NAC-LWT SAR, Revision LWT-14A

OPAL Amendment

List of Changes, NAC-LWT SAR, Revision LWT-14A

**Figure 7.1-2 LEU MTR Fuel Basket Loading Guidelines for 30 W Uniform Loading –
Maximum 470 grams ^{235}U**

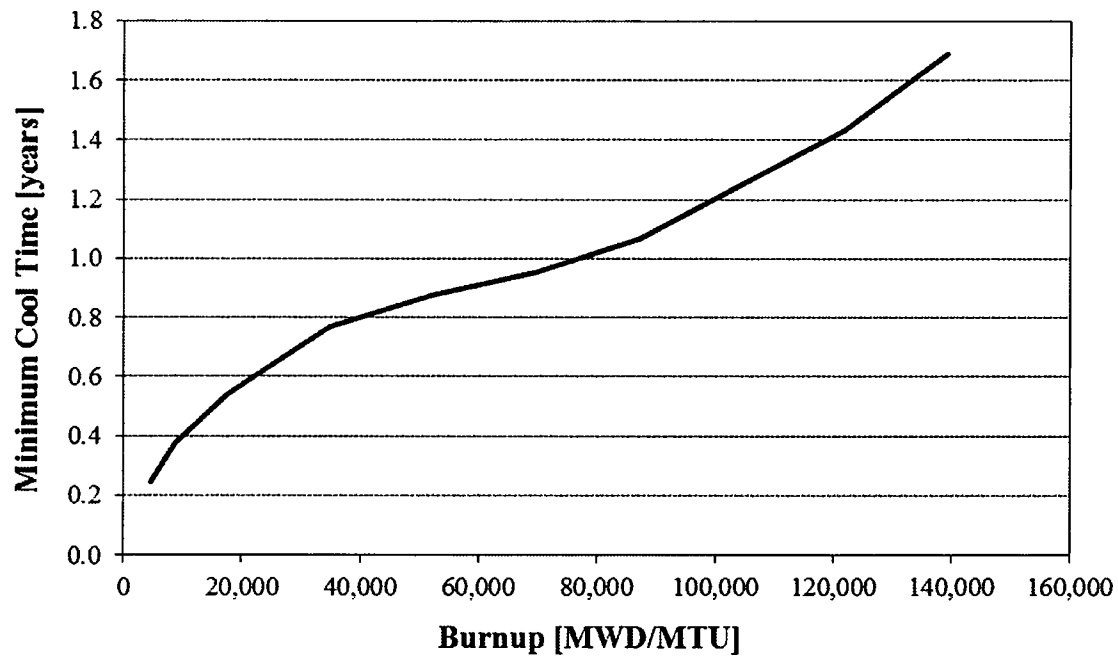
- Pages 7-i thru 7-ii, updated the Table of Contents to reflect text flow changes to page numbers and the List of Figures to revise Figure 7.1-2, “LEU MTR Fuel Basket Loading Guidelines for 30 W Uniform Loading – Maximum 470 grams ²³⁵U” and include new Figure 7.1-12, “LEU MTR Fuel Basket Loading Guidelines for 30 W Uniform Loading – Maximum 640 grams ²³⁵U” new Figure 7.1-13, “LEU MTR Fuel Basket Loading Guidelines for 40 W Preferential Loading – Maximum 490 grams ²³⁵U.”
- Page 7.1-2, modified text near the end of the second paragraph in section 7.1, “Procedures for Loading Packages.”
- Pages 7.1-19 thru 7.1-22, modified text throughout section 7.1.5, including text flow changes.
- Page 7.1-24, revised Figure 7.1-2, and the title, “LEU MTR Fuel Basket Loading Guidelines for 30 W Uniform Loading – Maximum 470 grams ²³⁵U.”
- Pages 7.1-25 thru 7.1-29, revised Figures 7.1-3 thru 7.1-7.

Figure 7.1-12 LEU MTR Fuel Basket Loading Guidelines for 30 W Uniform Loading
- Maximum 640 grams ^{235}U

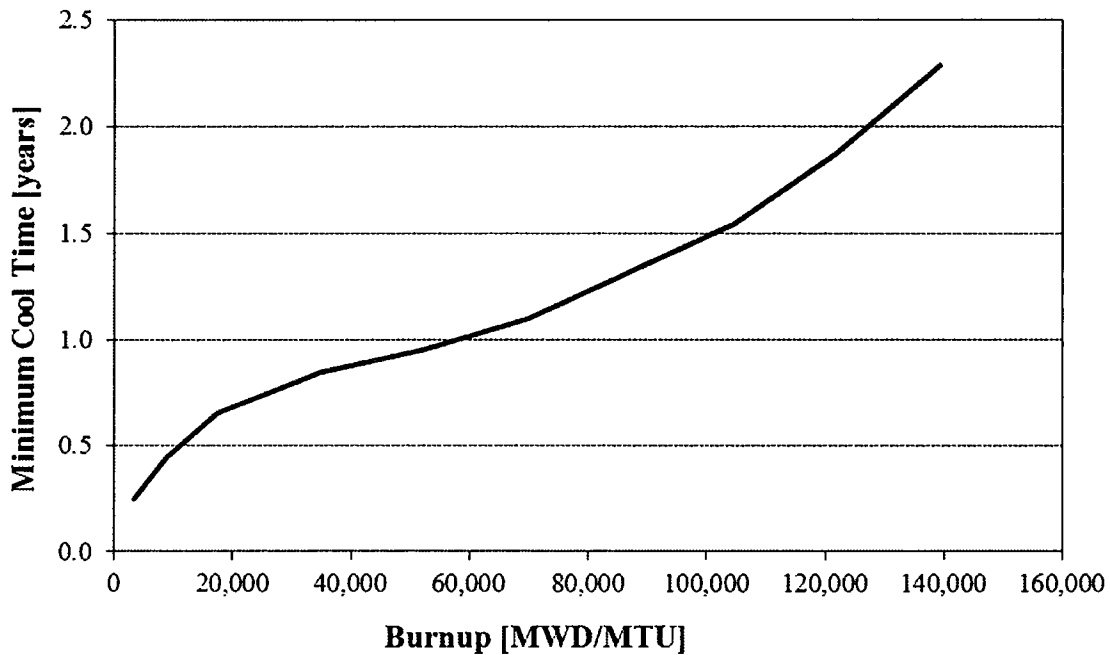
- Page 7.1-33, added new Figure 7.1-12, “LEU MTR Fuel Basket Loading Guidelines for 30 W Uniform Loading – 640 grams ^{235}U .”
- Page 7.1-34, added new Figure 7.1-13, “LEU MTR Fuel Basket Loading Guidelines for 40 W Preferential Loading – Maximum 490 grams ^{235}U .”
- Pages 7.1-35 thru 7.1-48, text flow changes.
